SUBDIVISION COMMITTEE  
METROPOLITAN AREA PLANNING COMMISSION

STAFF REPORT  
(One-Step Final Plat)

CASE NUMBER: S/D 98-49 - CORPORATE LAKES 3RD ADDITION

# EXHIBIT

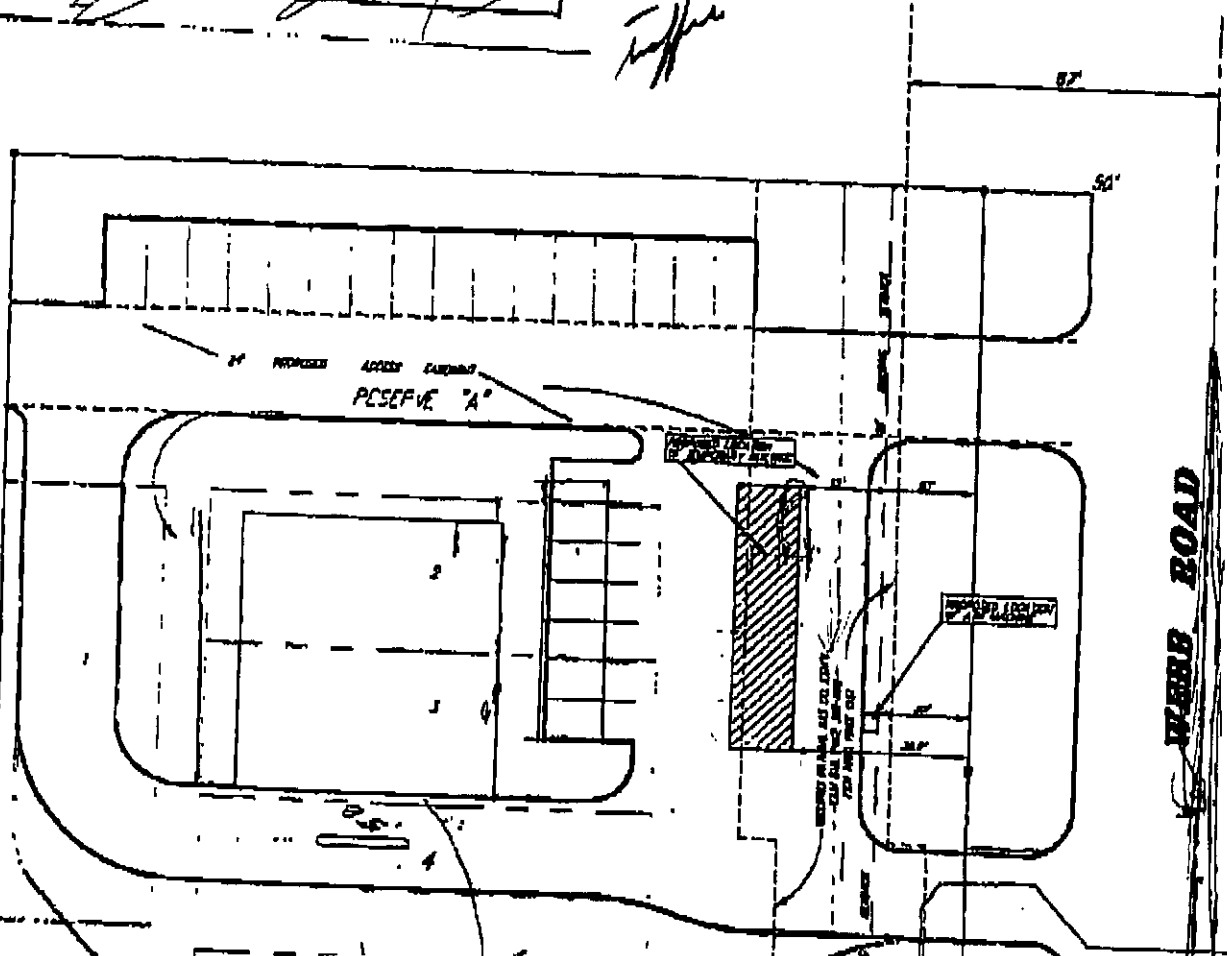
*left turns N-bound  
could possibly back  
traffic into control*

*←  
highway  
1998 11/29*

# EXHIBIT

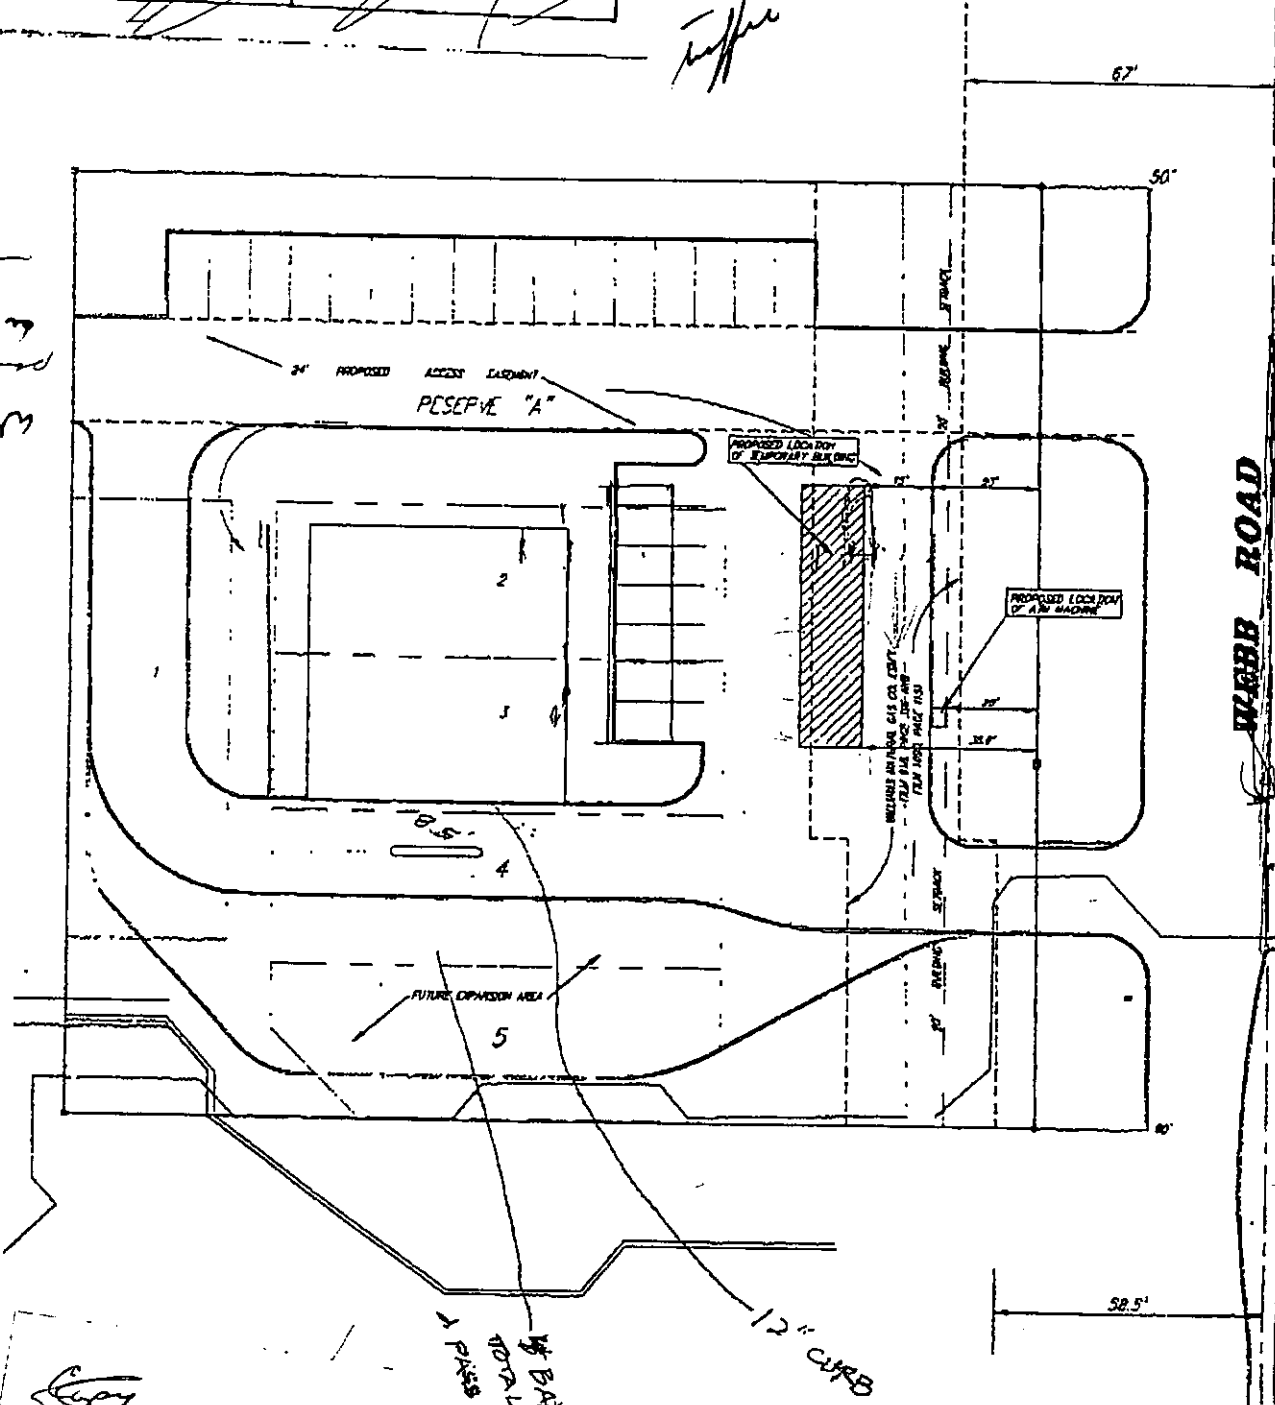
left turns N-bound  
could possibly back  
traffic into Central

←  
regards to  
paved  
area

DECK?

FULL  
MEDJ

← BERT'S  
NOT A  
1 PAVED UNITS

Requires Sidewalk replacement  
across fall footage

# EXHIBIT

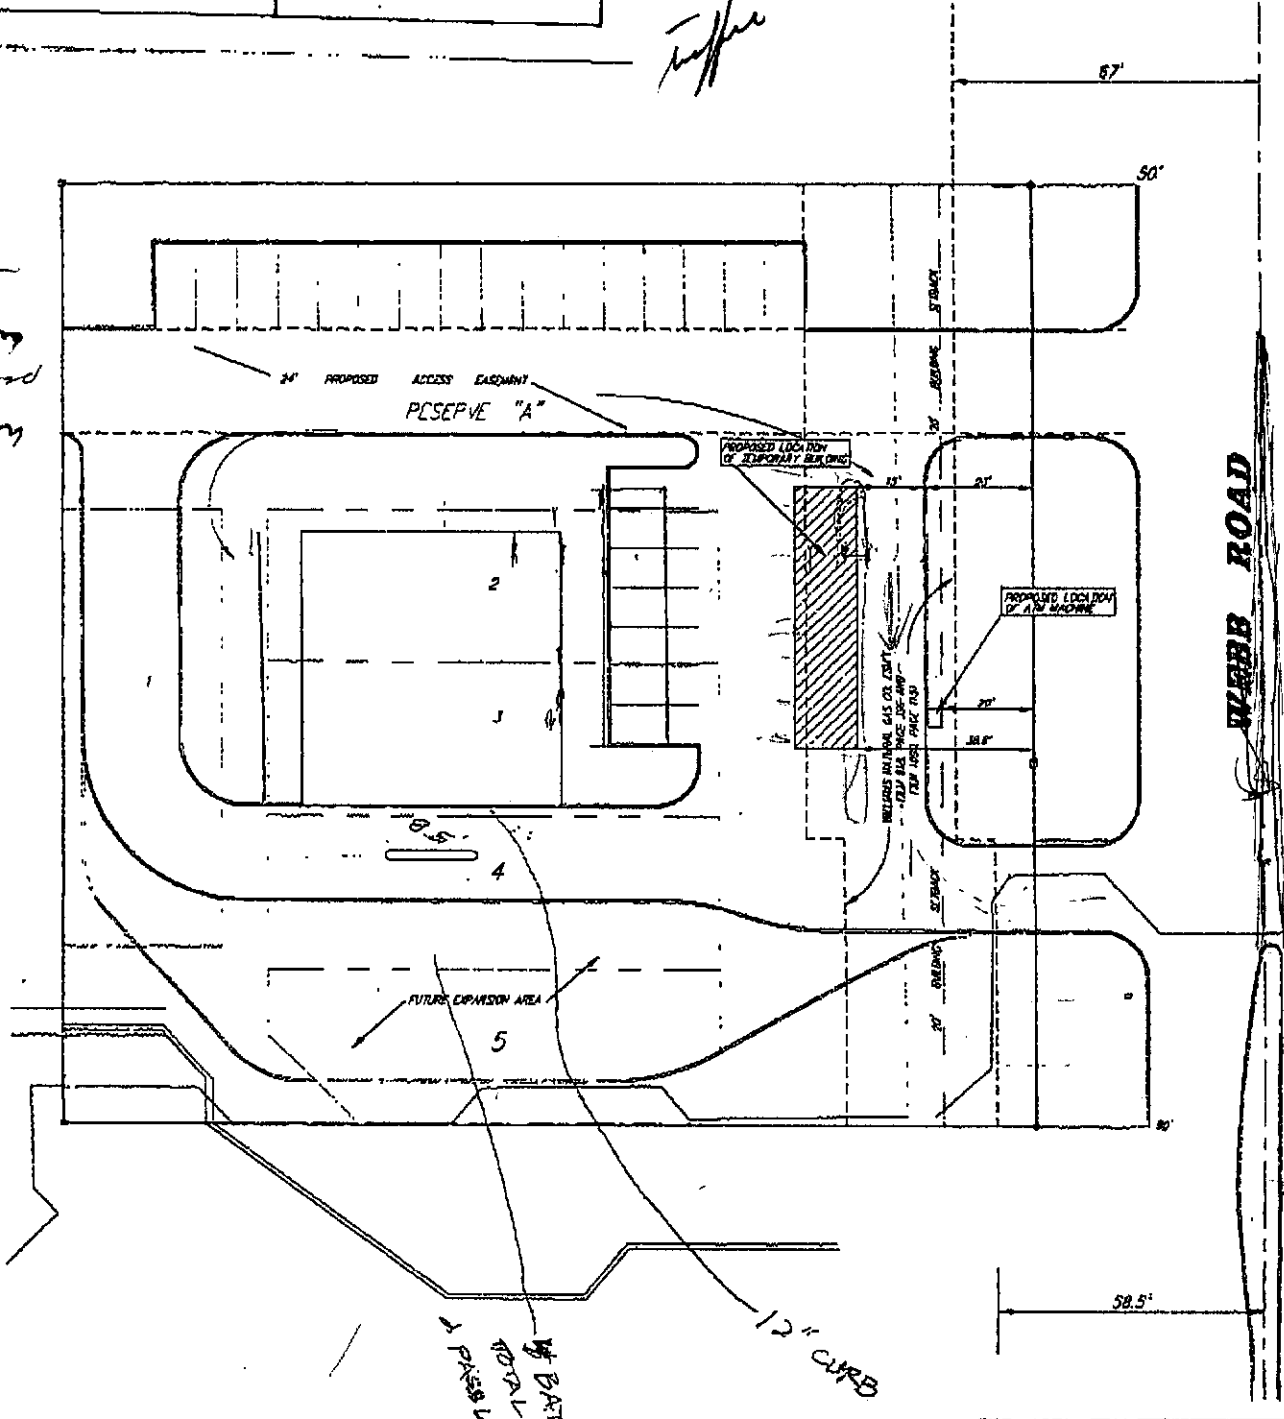
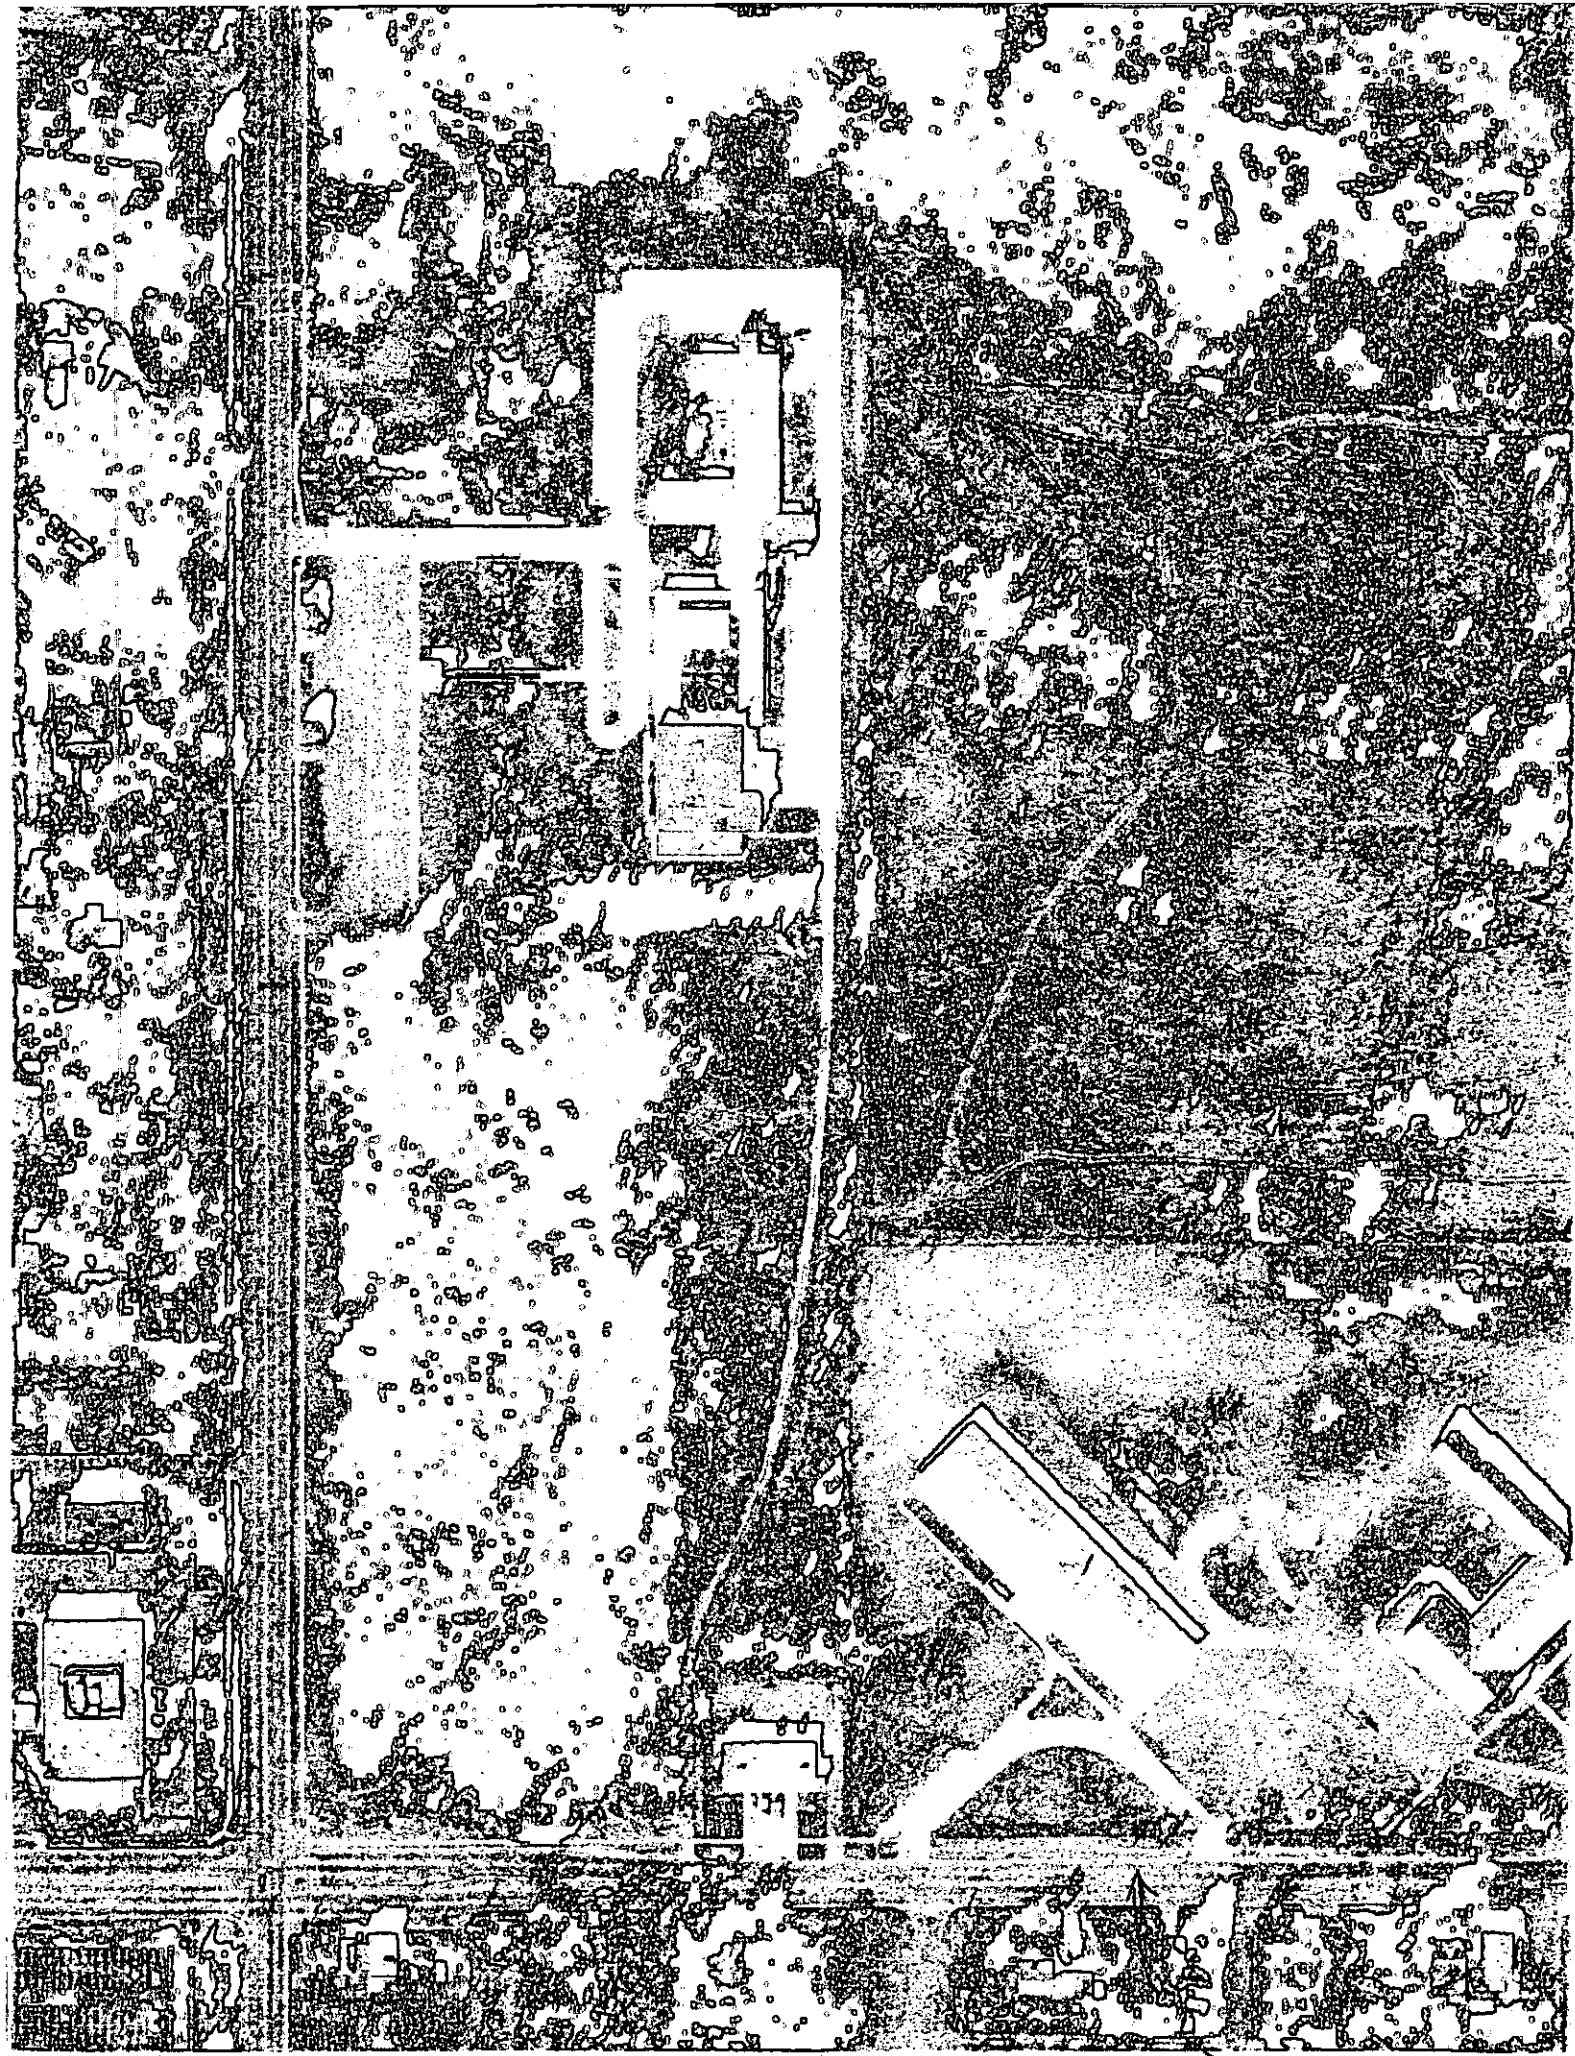
*left turns at-board  
could possibly back  
traffic into Central*

*←  
changes in  
ground  
level*

*DECEL?*

*FULL  
MEDIAN*

*Requires Sidewalk replacement  
across full frontage*
